Committee Secretary,  
State Development, Natural Resources and  
Agricultural Industry Development Committee,  
Queensland Parliament.

**Re: Submission for the Mineral Resources (Galilee Basin) Amendment Bill 2018**

## Some concerns regarding the assessment of potential water impacts of planned longwall mining at the Carmichael coal mine

**Figure 3.** Comparison of drainage zone heights from Ditton geology equation with  $t'=10$  and Tammetta’s equation with respect to Tammetta’s S1 database.

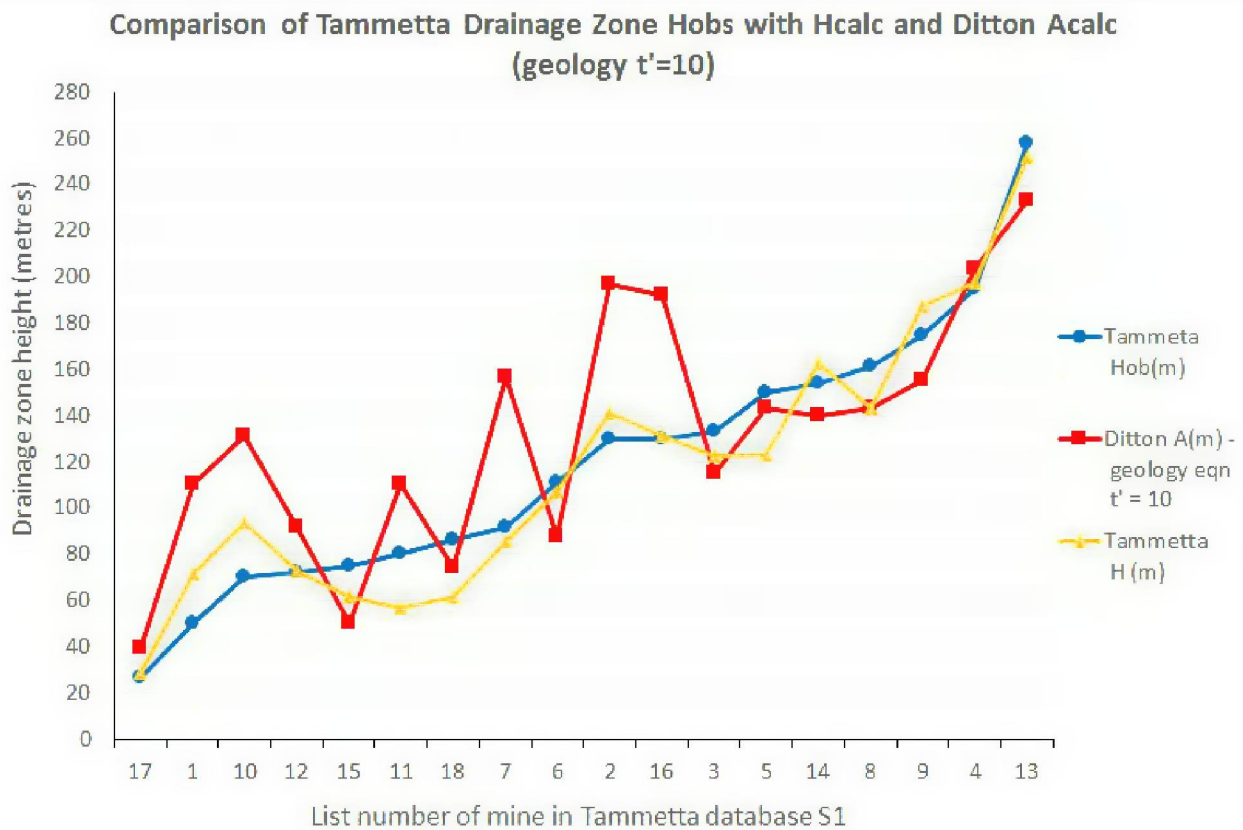
In providing advice to Adani, Merrick adopts a notably small value of 10 metres for the adjustment term. As Figure 3 below illustrates, with a small value of the adjustment term ( $t'=10$ ) the Ditton geology equation returns drainage zone height estimates that are similar to those provided by the Tammetta equation and the measured (centreline piezometer) heights of Tammetta's database, where the represented mining geometry parameters (extraction depth, width and height) are relatively large.

Merrick’s use of a relatively small value for the adjustment term of Ditton’s geology equation, the drainage zone height estimates from that equation are similar to those of the Tammetta equation, where the mining geometry is relatively large. The agreement is however poor for smaller mining geometries.

**Figure 4.** Comparison of drainage zone heights from Ditton’s geology equation with  $t'=30$  and Tammetta’s equation with respect to Tammetta’s S1 database.

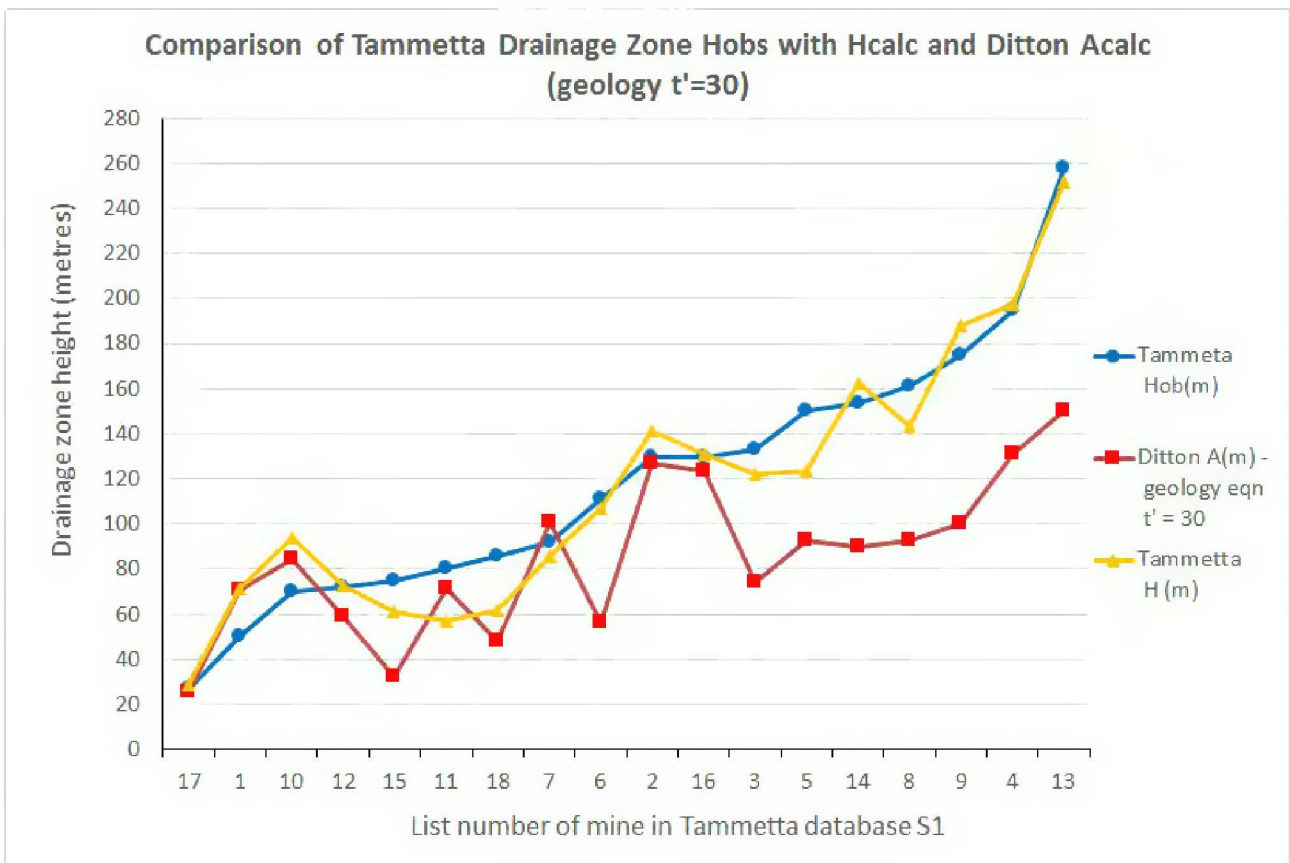
Reflecting its flawed nature however, the Ditton geology equation agreement with the measured heights is then poor for other mining geometries in the database. Figures 4 compares the height estimates from the Tammetta equation and the Ditton geology equation, with respect to the

Merrick used an adjustment term of 30 in using Ditton’s geology equation for recent assessments for the Dendrobium mine, located below the Metropolitan Special Area of Sydney’s water catchment. The agreement between the drainage zone height estimates from the Ditton equation and those from the Tammetta equations is generally poor.

**Figure 6.** Comparison of Mine 1 drainage zone heights obtained from the Ditton equation (A) and the Tammetta equation (H), using Merrick’s adjusted extraction thickness for the double extractions.

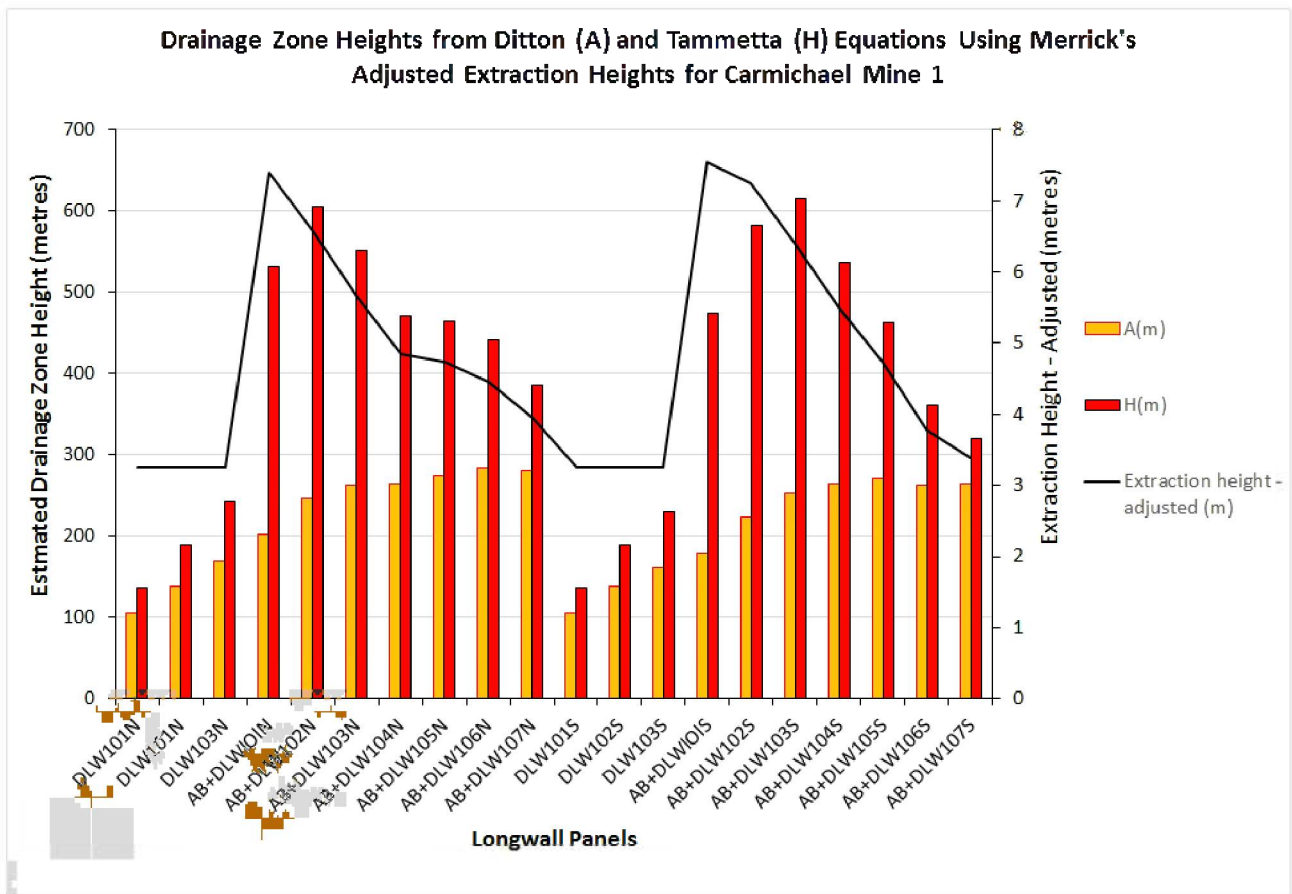
Figure 6 below contrasts the very different drainage zone height estimates for the Mine 1 double seam extractions provided by the Ditton geology equation (with an adjustment term,  $t'$ , of 10

metres) with those provided by the Tammetta equation, using the effective mining heights inferred from Table 3 of Dr Merrick's advice to Adani. Figure 6 includes a trace depicting the effective mining heights inferred from Table 3 of the advice to Adani. The large differences in the drainage zone height estimates for the double seam extractions provided by the Ditton equation and those of the Tammetta equation, reflect the implausible insensitivity of the former to variations in extraction height (or thickness).

The Tammetta equation suggests the drainage zone would reach the surface for all but the AB+DLW107N, AB+DLW106S and AB+DLW107S double seam extractions (labelled here with respect to the overlying AB longwall). These are the deepest Mine 1 extractions and have the smallest 'effective mining heights', being 3.95, 3.78 and 3.38 metres respectively. Noting the extraction height of the D seam alone is 3.35 metres, these depth determined heights point to the implausibility of the Ditton 'effective mining height' method.

**Figure 8.** Dependence of the Ditton equation estimates and the Tammetta equation estimates with depth below ground.

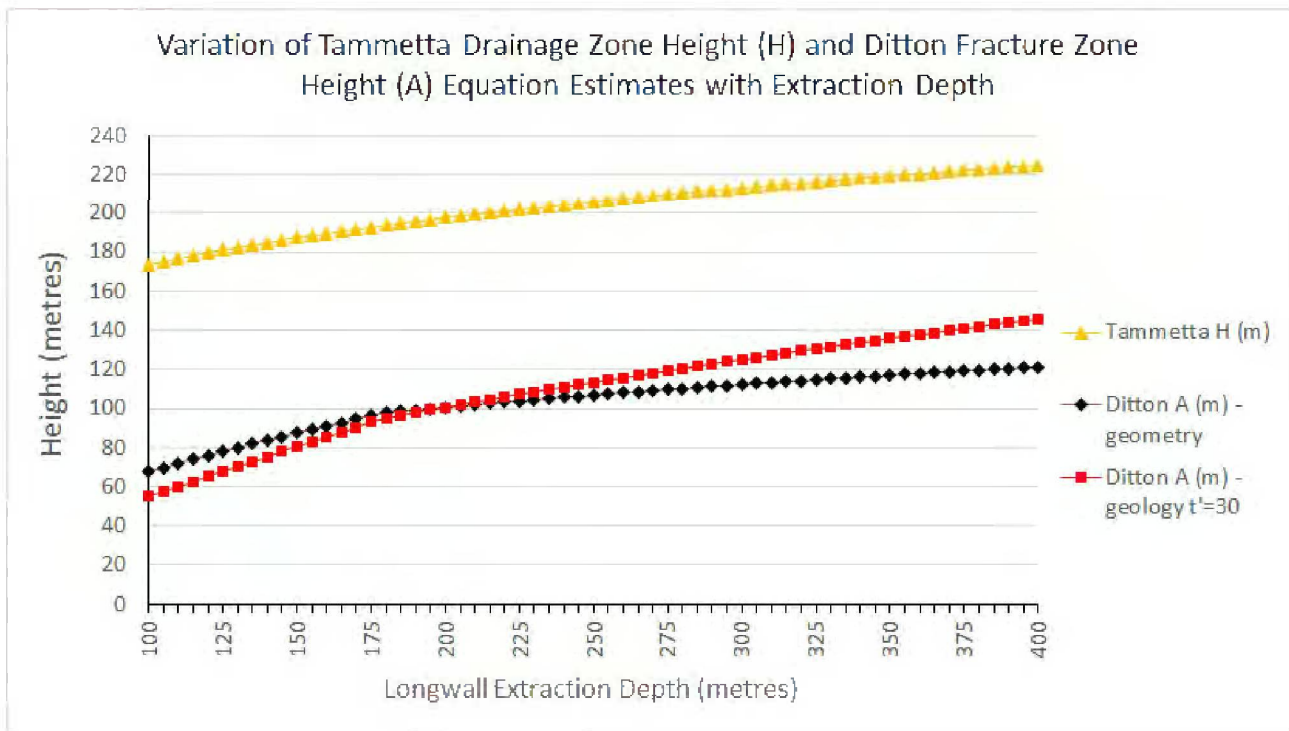
Figure 8 below graphs the drainage zone estimates provided by the Ditton equations and the Tammetta equation with respect to depth of cover and this shows that in each case the drainage height slowly increases with depth. There would appear to be no reason to expect this would not also be the case for multi-seam extractions. On the contrary, Tammetta suggests the drainage zone height increase with depth may be greater than found for single seam extractions.

**Figure 10.** Comparison of Mine 1 drainage zone heights returned by the Ditton geology equation ( $t'=10$ ) using summed mining heights and Merrick’s adjusted mining height.

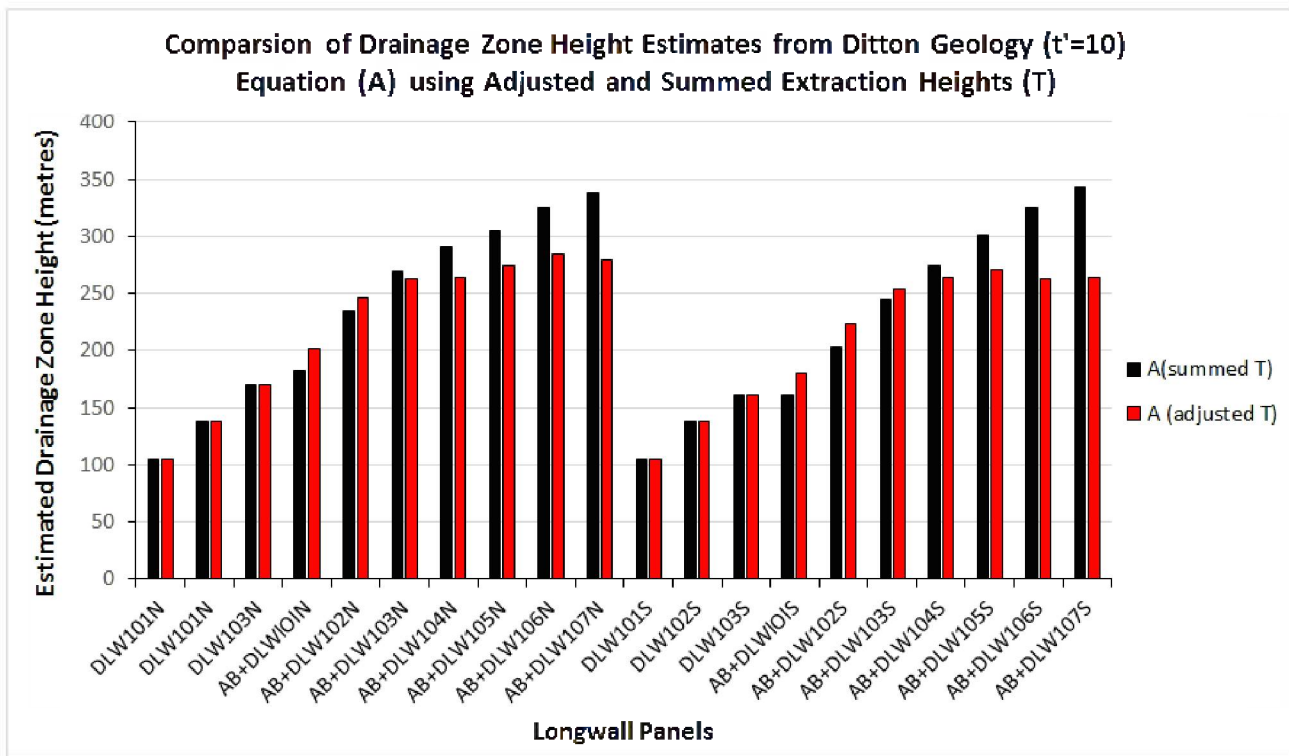
Figure 10 contrasts the drainage zone height estimates from the Ditton geology equation using an adjustment term of 10 metres and the effective mining heights that appear to have been used by Merrick for Mine 1, with the heights obtained using the summation of the proposed Mine 1 AB and D seam mining heights. The Tammetta equation is used to provide the same comparison in Figure 11.

**Figure 12.** Comparison of drainage zone height estimates from Tammetta equation obtained by summing individual seam thicknesses and summing individual seam height estimates.

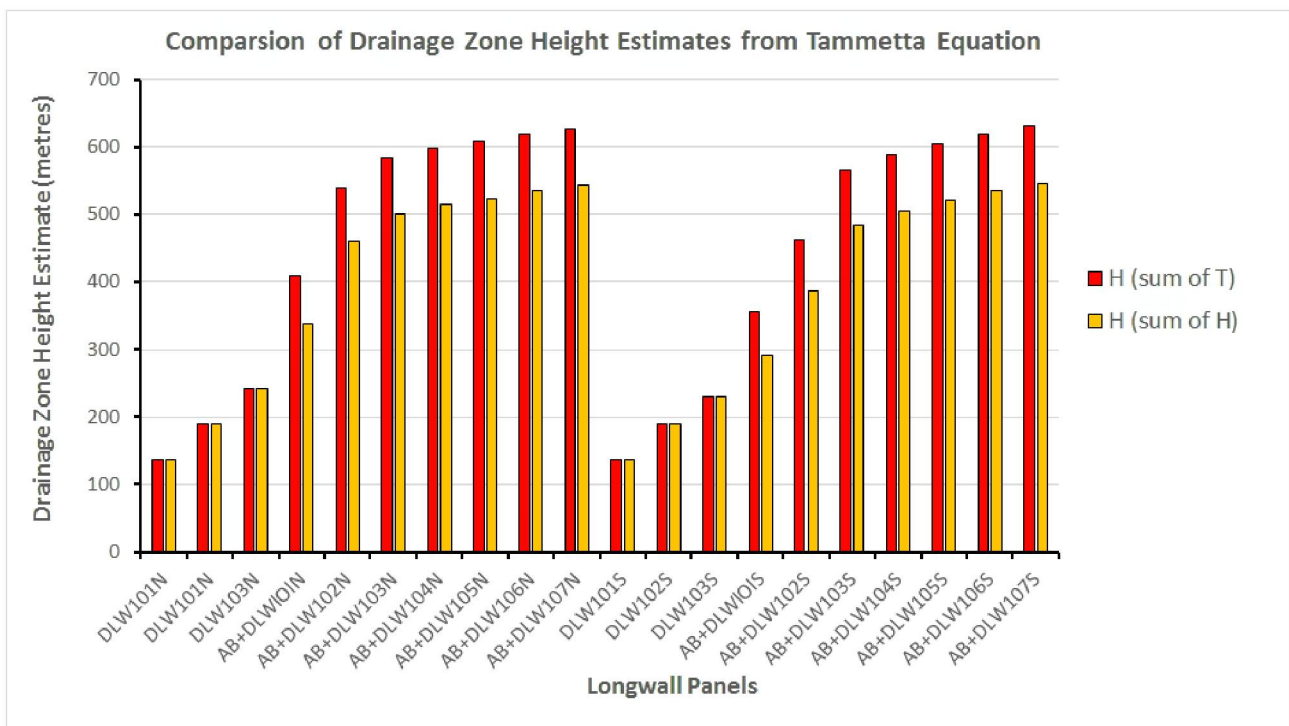
Figure 12 compares the estimated drainage zone height obtained from the Tammetta equation using the summed AB and D seam mining heights, with the summation of the drainage zone height estimate for the AB seam and the drainage zone height estimate for the D seam. The latter drainage zone height estimate is approximately 15% lower than the former; Tammetta suggests (see quote above) the latter is likely to be an underestimate. The drainage zone height estimate obtained by adding together the height estimates returned by the Tammetta equation, using the average cover depths listed in Table 3 of Merrick's advice to Adani, for the AB seam extraction and that for the D seam extraction again suggests that the drainage zone would reach the surface over all of the proposed longwall extractions. This is depicted in Figure 13. Figure 14 is Dr Merrick's depiction of the longwalls where the drainage zone reaches the surface, based on his calculations.

**Figure 13.** Depiction of the drainage zone reaching the surface over the proposed Carmichael longwall extractions.

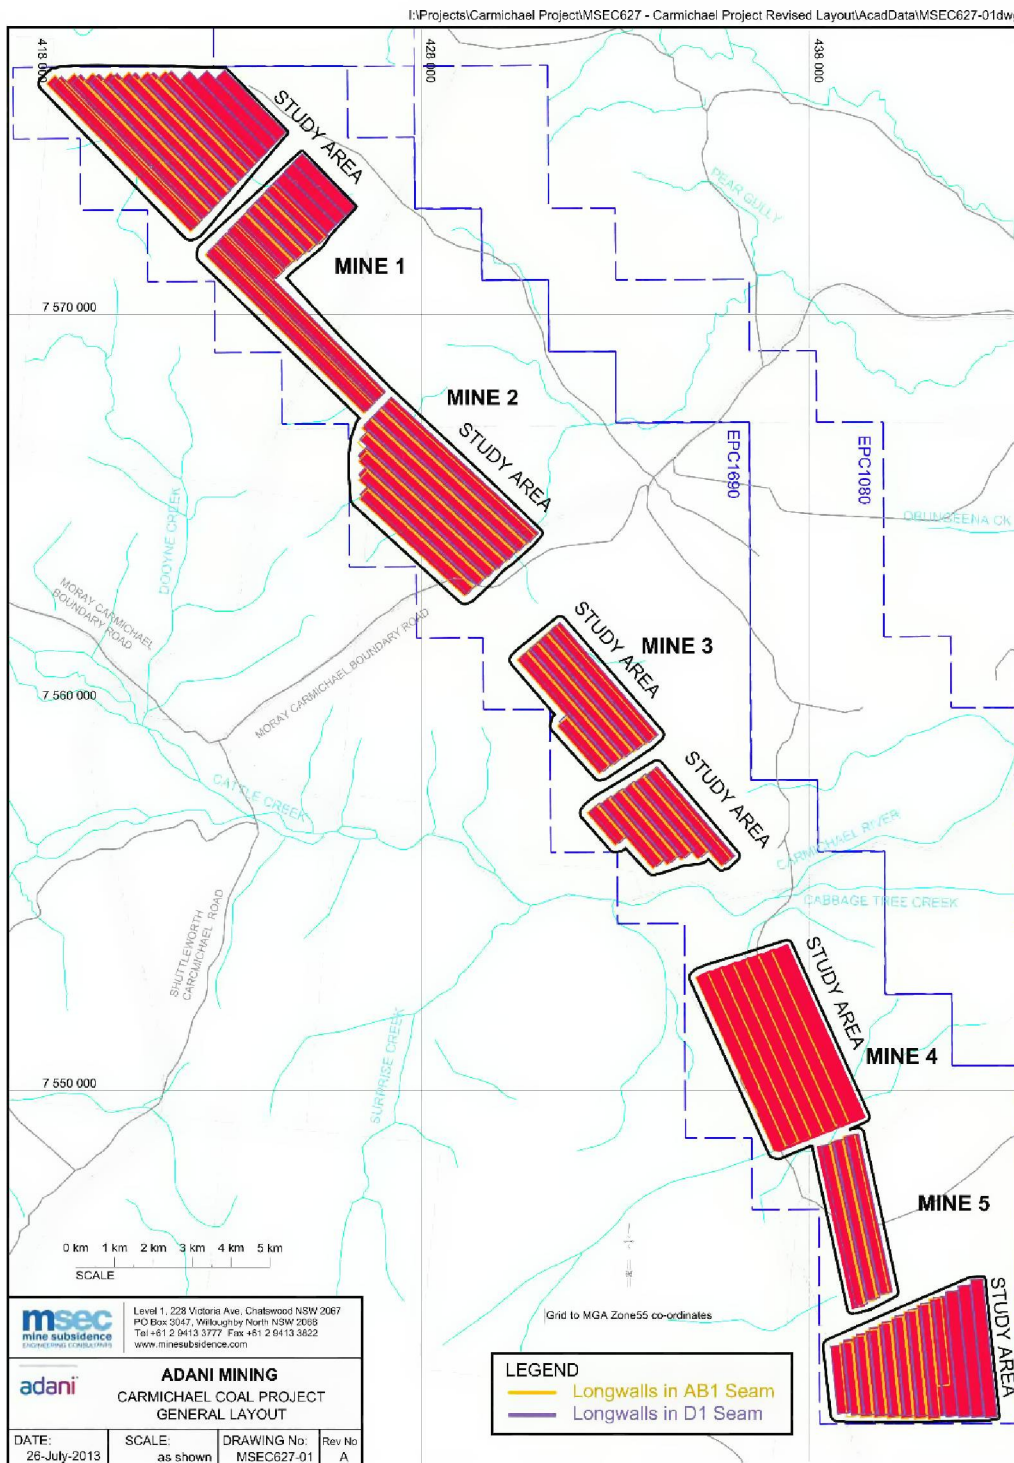
- Whereas Dr Merrick finds that the drainage zone will reach the surface over 40% of the planned longwall extractions, application of the Tammetta equation suggests the drainage zone will reach the surface over all of the planned extractions.

The Tammetta equation, using the average cover depths listed in Table 3 of Merrick’s advice to Adani[6], suggests the drainage zone will reach the surface over all of the proposed longwall extractions of the Carmichael project. This is indicated by the red colouration; the orange lines outline the AB seam extractions and the grey lines outline the lower D seam extractions. Most of the AB extractions overlie D seam extractions.

**Figure 15.** Xenith's revised depiction of the local area geology[33]

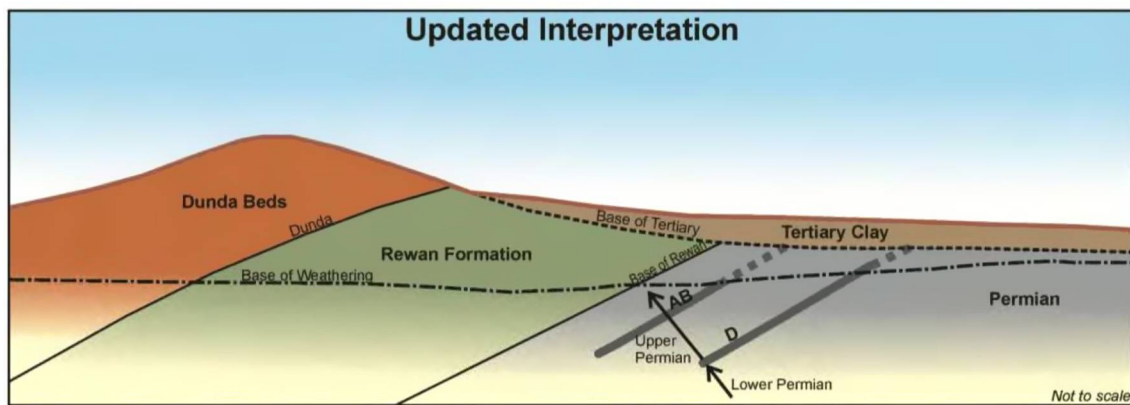
Bearing in mind that the drainage zone would extend vertically, the revised geological interpretation by Xenith in October 2012 suggests (see Fig. 15) that most of the D seam extractions would not be overlain by the Rewan formation. Figure 15 also suggests that while it appears that the AB seam extractions would largely be overlain by the Rewan formation, the thickness of cover would vary considerably. The Rewan does not reach the surface over the proposed extractions. It’s not known how representative this cross-section is of the lithography over the planned extractions. Nor is it known if the lithography has been determined over the centre of the proposed extractions.

The depiction suggests that most of the D seam extractions would not be overlain by the Rewan formation. It also suggests that while it appears that the AB seam extractions would largely be overlain by the Rewan formation, the thickness of cover would vary considerably. The Rewan does not reach the surface over the proposed extractions. It's not known how representative this cross-section is of the lithography over the planned extractions. Nor is it known if the lithography has been determined over the centre of the proposed extractions.
